CLIENT
Barni & Patrizia Askaro

PROJECT NO.
19xsy011

ADDRESS
4 Loch Maree
Vaucluse
NSW 2030

TITLE 3D View_Figure 15
Revised Built Form
Lowered 800mm

TITLE **3D View_Figure 20
Revised Built Form
Lowered 800mm**

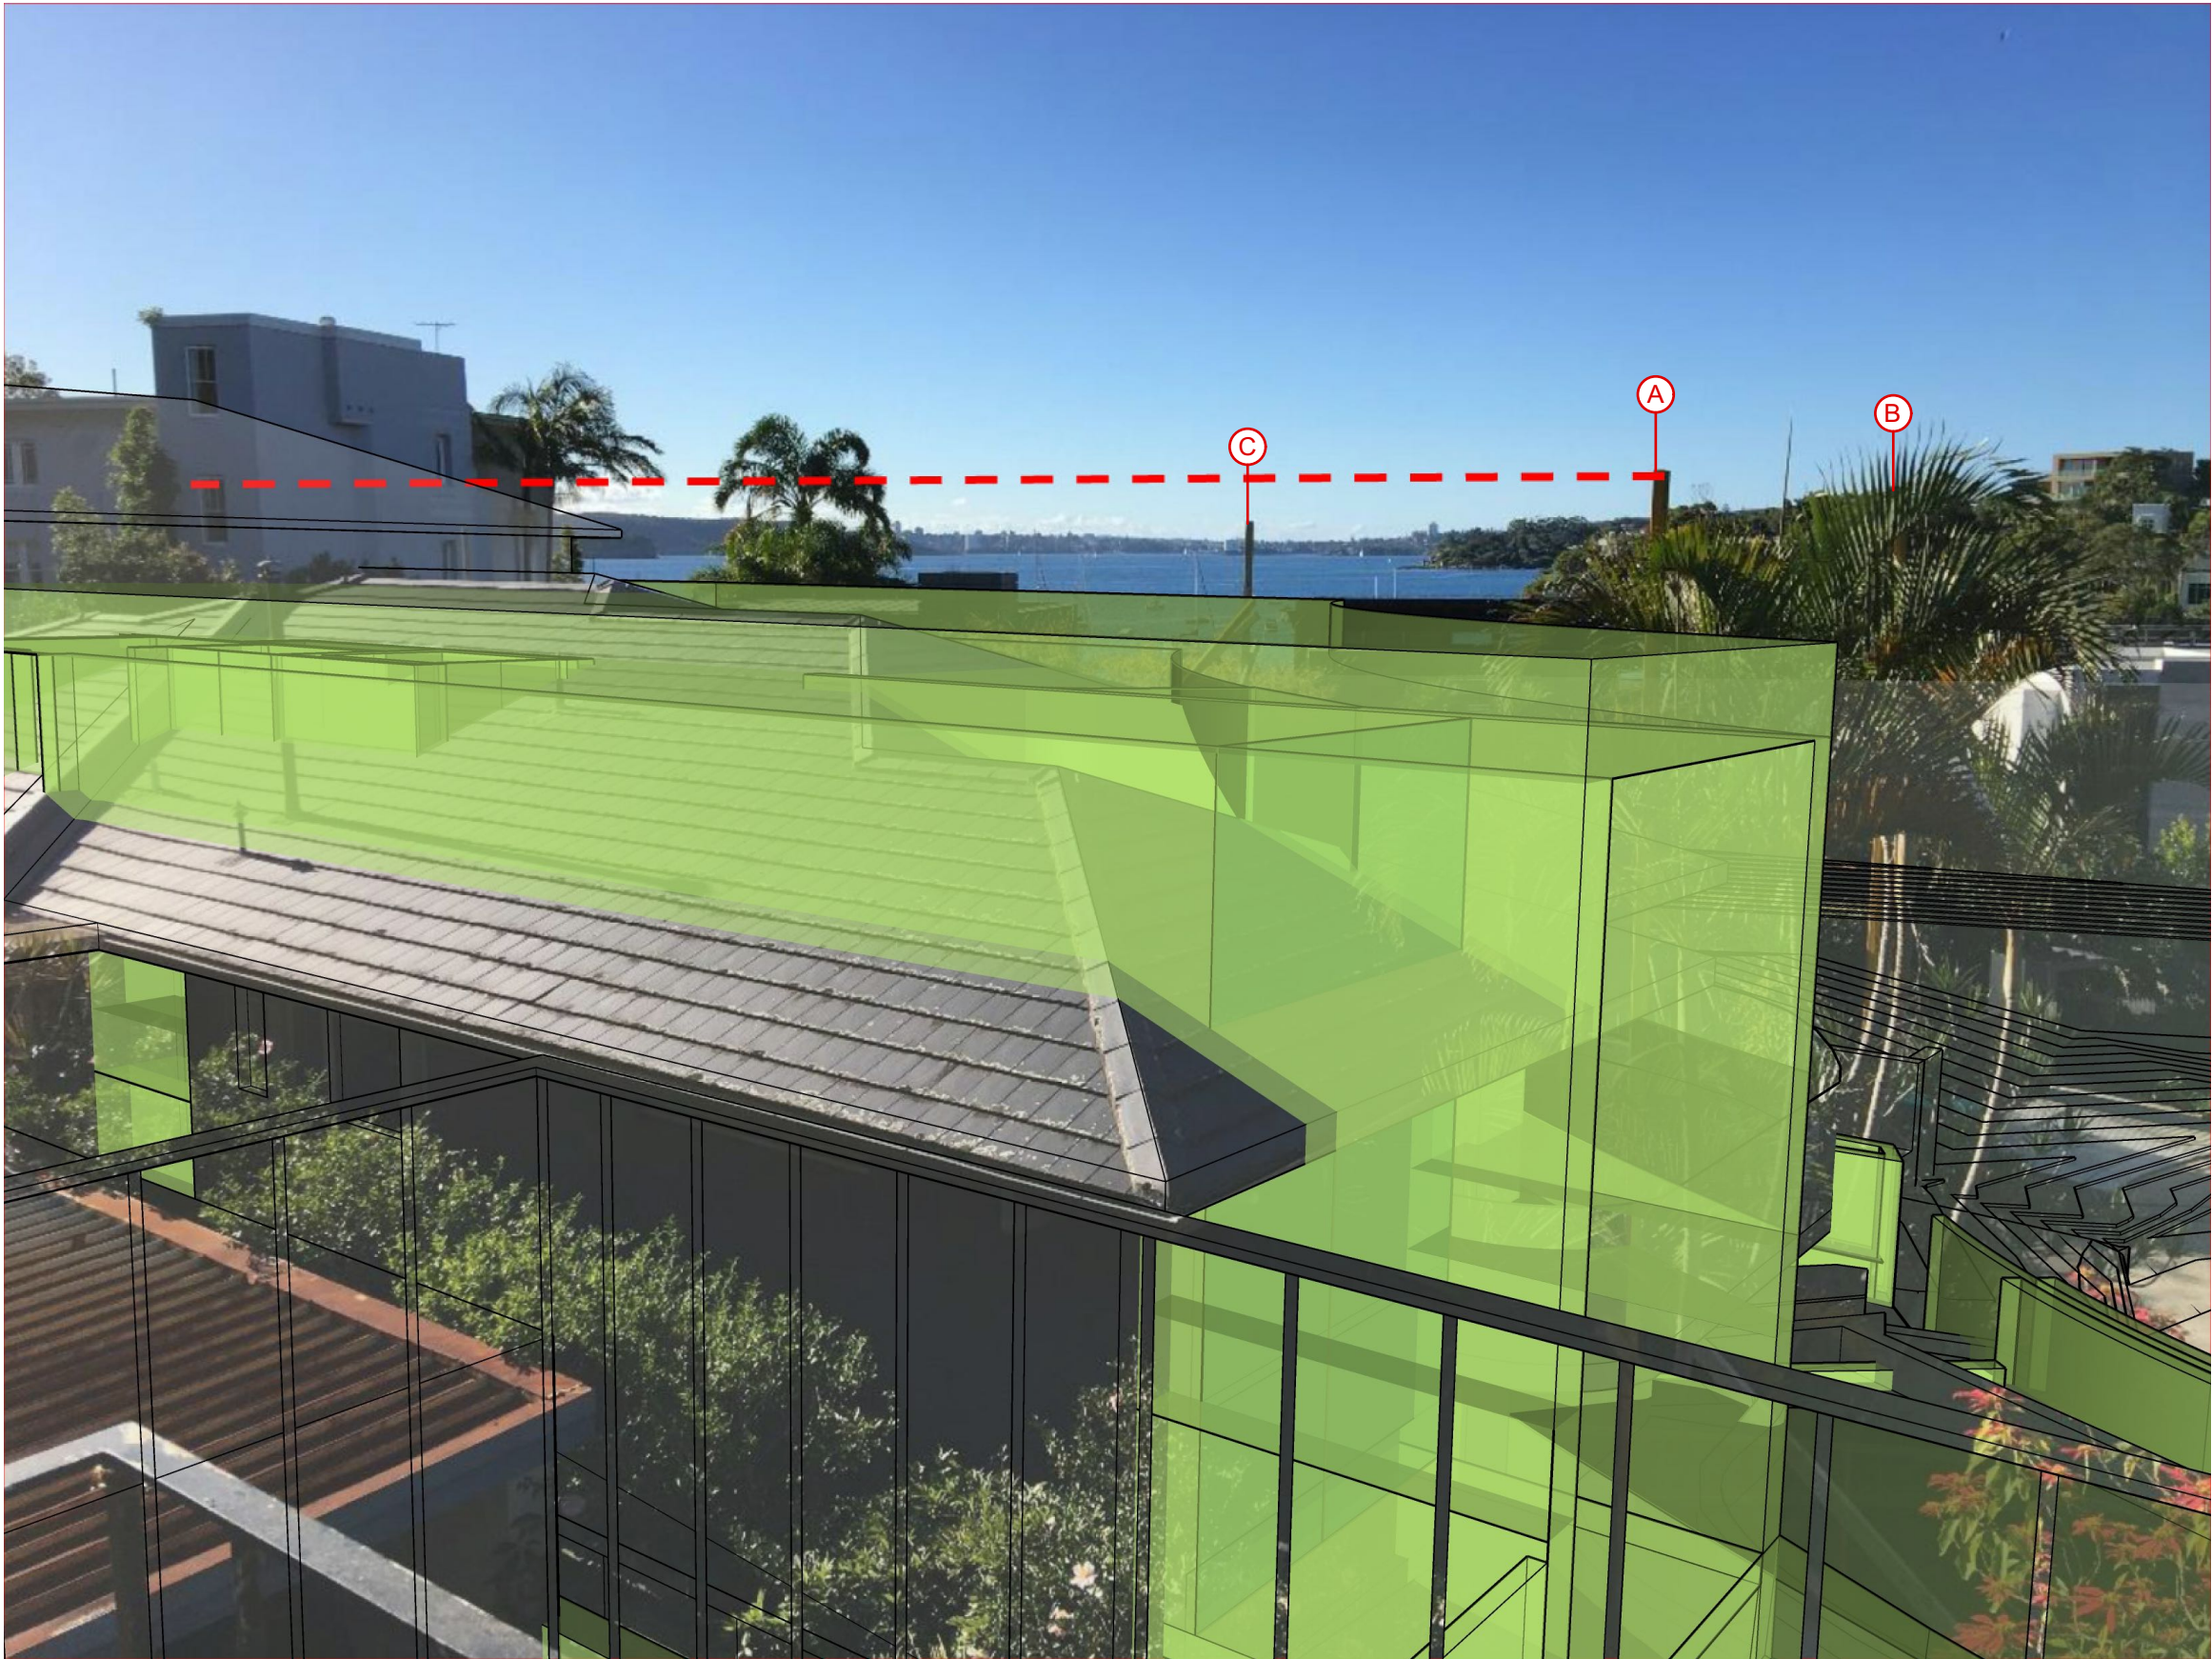
- note:**
1. Revised built form southern boundary setback at 2700 [previous south setback was 3400]
 2. Driveway stormwater requires pump out station for building lowered 800mm
